FCC ID: 004-IQ310CST IC: 3538A-IQ310CST

Applicant: IDENTEC SOLUTIONS AG

Class II Permissive Change

This application is for a class II permissive change to the originally certified RFID System i-Q310CST

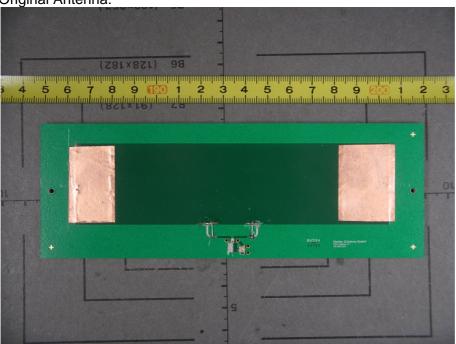
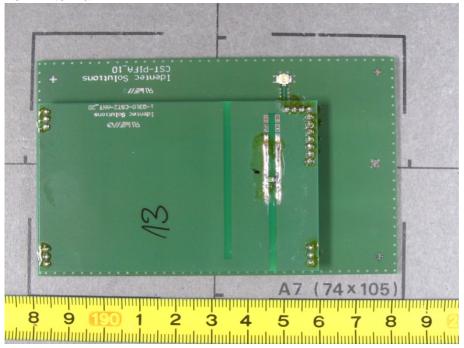
Change: The antenna geometry is changed from originally an inverted patch to a tuned Planar Inverted F-Shaped Antenna (PIF) in order to improve antenna pattern, antenna gain remained the same as original version.
